Interactive comment on “Analysis of actinic flux profiles measured from an ozone sonde balloon” by P. Wang et al.

Anonymous Referee #1

Fig. 1. Similar to Fig. 7d in the manuscript. Both single layer (red) and two layers (green) cloud simulations are shown.

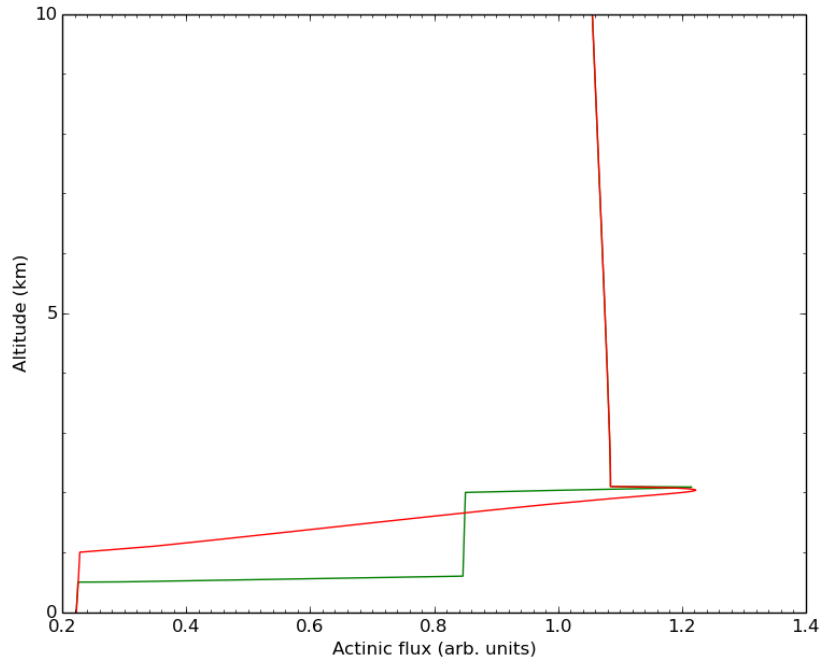
- **Page 31183, line 17:** It is straightforward with a radiative transfer model to include several cloud layers and this should be done to better reproduce the measurements. In Fig. 1 (this review) single cloud layer (red) and two cloud layers (green) simulations are included. The total optical depth was 25 in both cases and the solar zenith angle as in Fig. 7d. The wavelength is 550 nm, the surface albedo 0.15 and no aerosols were included. Clearly the two layers simulation better resembles the measurements in Fig. 7d.
The really intriguing feature with the measurements shown in Fig. 7d is the decrease in radiation as the altitude increase from about 0.5 to 2.0 km, that is between the two cloud layers. Below a sufficiently thick cloud little or no vertical variation is expected as shown by the model results in Fig. 1 (this review), green line. The behaviour of the measurements in this altitude range is unexpected. Aerosols may play a role, but it is not at all clear to this referee what the reason is for this behaviour.

Fig. 2. Similar to Fig. 11d in the manuscript. Note how the normalised actinic flux profiles change with wavelength below 15 km.

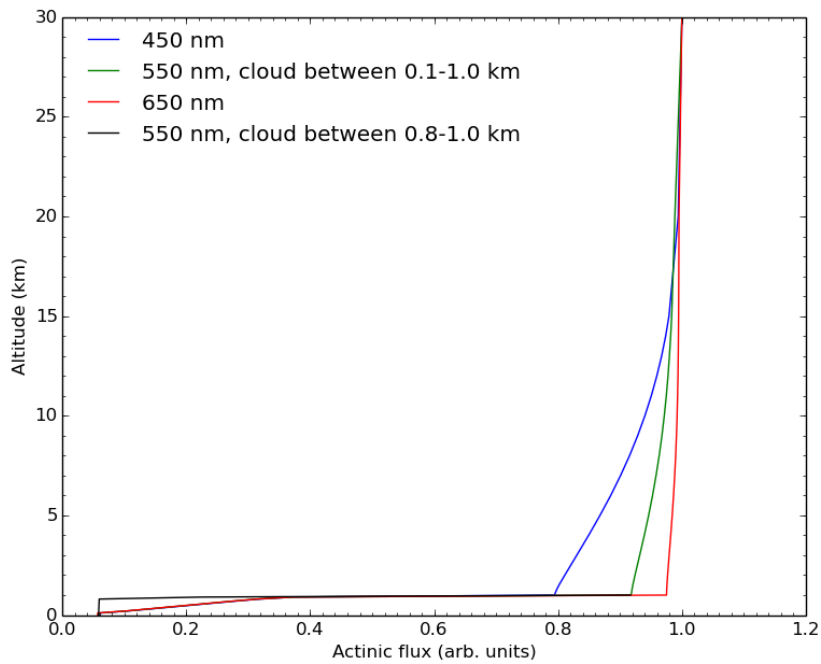
- **Page 31185, line 5:** What is meant by “properly simulated”?
- **Page 31185, lines 6-23:** For large solar zenith angles a difference between the measured and simulated actinic flux is seen below about 10 km in Fig. 11d. It is speculated that full spherical geometry is needed to explain this discrepancy. However, the DAK simulations are made for the single wavelength of 550 nm under the assumption that this single wavelength best describes the broad band response of the diode. This assumption may hold for small solar zenith angles, but not necessarily for large solar zenith angles. The clear-sky actinic flux varies with wavelength (Rayleigh scattering). To investigate this effect the actinic flux was calculated as a function of altitude for wavelengths of 450, 550 and 650 nm for a solar zenith angle of 75° . A water cloud with optical thickness of 30 evenly distributed between 0.1 and 1.0 km, was included in the simulations. Pseudo-spherical geometry was assumed. In Fig. 2 (this review) the actinic flux normalised to its value at 30 km is shown for the three wavelengths. It is seen that the actinic flux varies considerably with wavelength below about 15 km and that a wavelength of 650 nm reasonably well resembles the measurement presented in Fig. 11d. Thus the choice of 550 nm in the DAK simulations is not representative for large solar zenith angles. This example very clearly demonstrates the danger involved when using a single wavelength to simulate an instrument with a broad spectral response. Rather than using a single wavelength, the DAK simulations should be made for all wavelengths covered by the diode and the resulting spectrum convolved with the spectral response of the diode.

Finally note the difference between the black and green lines in Fig. 2 (this review). For the green (black) line the cloud optical depth was evenly distributed between 0.1 (0.8) and 1.0 km. The black line best reproduces the red line in Fig. 11d of the manuscript, but it is not clear from the text how the vertical distribution of the optical depth was for the calculation presented in the manuscript.

- **Page 31187, line 5:** After the simulations have been redone accounting for the spectral response of the diode instrument, the shapes of measured and simulated actinic fluxes will most likely agree for $SZA > 75^\circ$ and the conclusions may be changed accordingly.
- **Page 31194, Fig. 4a-b:** Have you tried to use log-scale on both the x- and y-axes in Fig. 4a? And have you tried to use log-scale on the x-axis of Fig. 4b?
- **Page 31195, Fig. 5a-b:** Please mark the launch site in Fig. 5a or even better include a square marking the region shown in Fig. 5b. Fig. 5a looks like a MODIS image obtained directly from the MODIS web site. A little more work is warranted to make the presentation clearer.
- **Page 31195, Fig. 5c:** It is not marked which lines correspond to the measurement and the model. Also, it would be interesting to include a model/measurement ratio or difference plot.
